TORONTO STAFF REPORT

Subject: Final Report - Request to Lift the 'H' Holding Symbol from By-law No. 1994-149 and Site Plan Approval
Monarch Construction Limited and Water View Corporation
2115-2139 Lake Shore Boulevard West
File Number(s): CMB 20000011
(Lakeshore-Queensway)

File No. CMB20000011 - 2115-2139 Lake Shore Boulevard West (Phase 1A)
Compliance with Built Form Guidelines

Site Plan

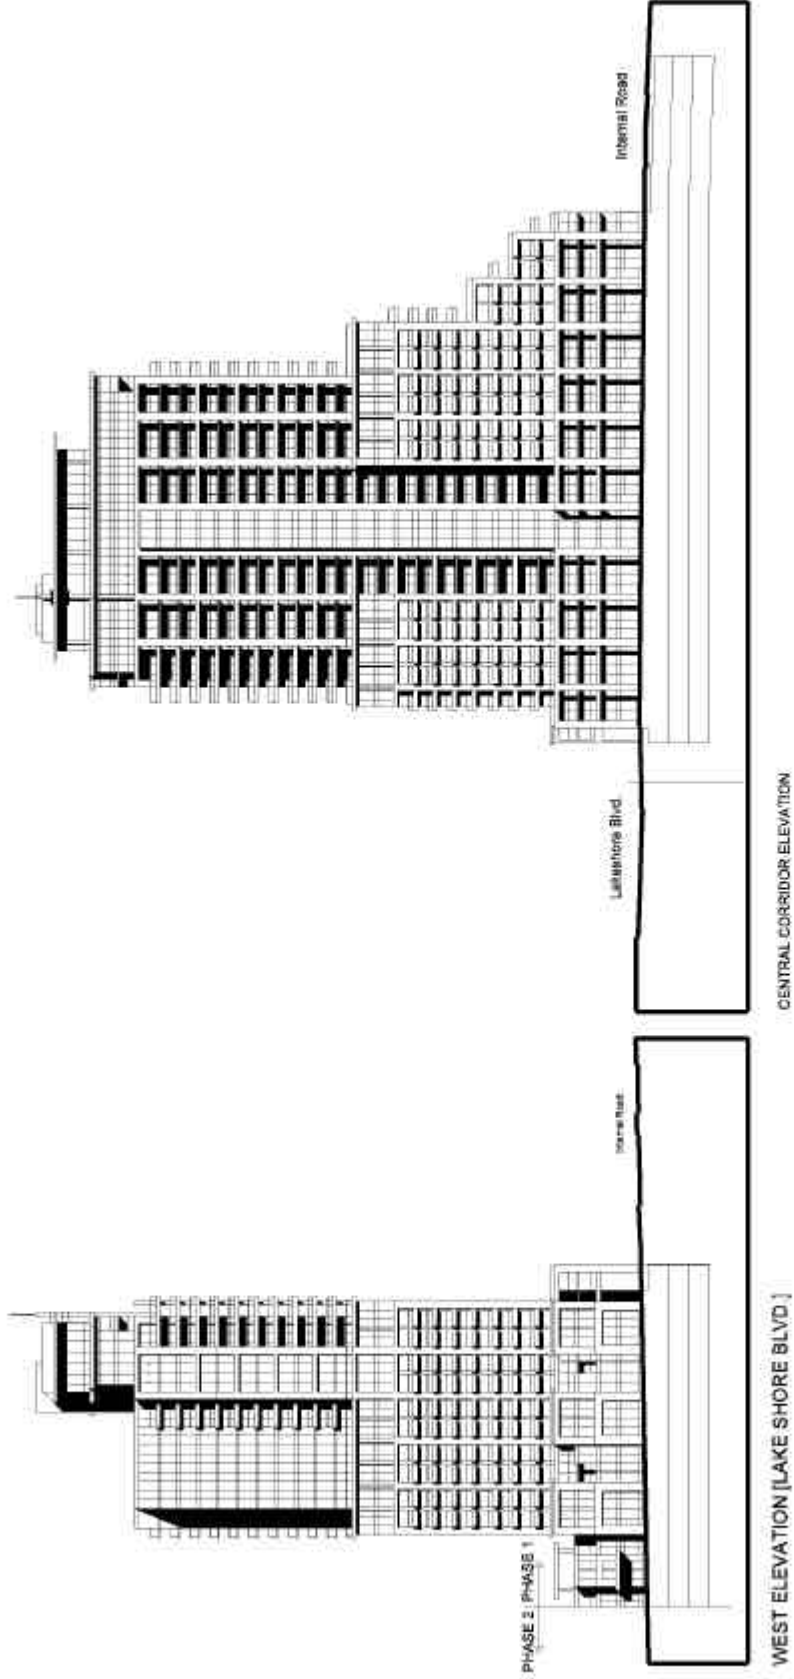
The applicant has been requested to revise the site plan to eliminate the three on-street parking spaces proposed on the west side of Right-of-way C, revise the elevations to reflect a reduced sky exposure and increase the width of the sidewalks adjacent to Right-of-way C to two metres as discussed in Attachment No 5. Prior to the finalization of the site plan a detailed sun and wind study is required.

The applicant is proposing as part of this phase of development, to construct the 35-metre right-of-way which will comprise the public street connecting Lake Shore Boulevard to the Village Court. The application also provides the required Right-of-Way C. Whereas The Guidelines anticipate servicing and vehicle access to be provided within the defined boundaries of Right-of-Way C, this application proposes vehicle and servicing access on the north side of the proposed building adjacent to Right-of-Way C. These activities are contained within the interior of the site and screened from Lake Shore Boulevard. Staff are prepared to accept this proposal given the opportunity it provides to create continuous pedestrian connections through Right-of-Way C connecting the new public street and the Village Court area to Newport Beach Park. In this regard, the application should be revised to eliminate the three on-street parking spaces proposed on the west side of Right-

of-way C. As well a 2 metre wide pedestrian sidewalk should be constructed on both sides of Right-of-way C connecting the new street to the adjacent parkland.

- (8) Submission of a revised sky exposure plan, sun and wind studies, a revised site plan that provides for the elimination of the three on-street parking spaces proposed on the west side of Right-of-way C, and the widening of the pedestrian sidewalks to two metres along Right-of-way C to the satisfaction of Urban Development Services prior to site plan approval.

Elevations

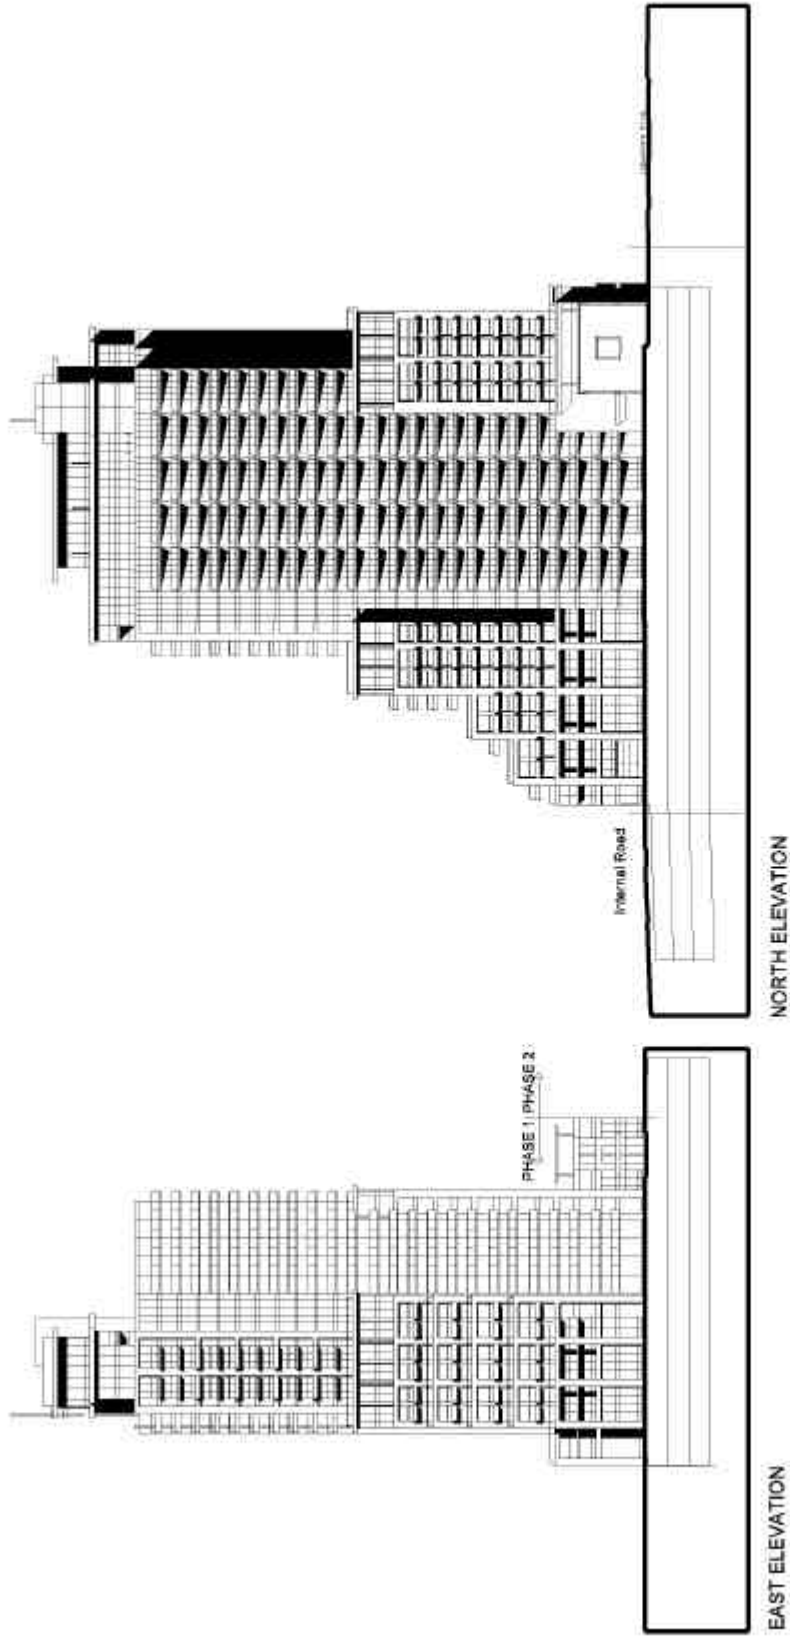
The proposed development exceeds the 50 percent sky exposure requirement set out in The Guidelines. Staff are prepared to provide the same flexibility on this site awarded to other applicants in the area with regard to sky exposure for buildings west of Right-of-way C. This application should be revised to improve the sky exposure in accordance with that achieved on those sites.
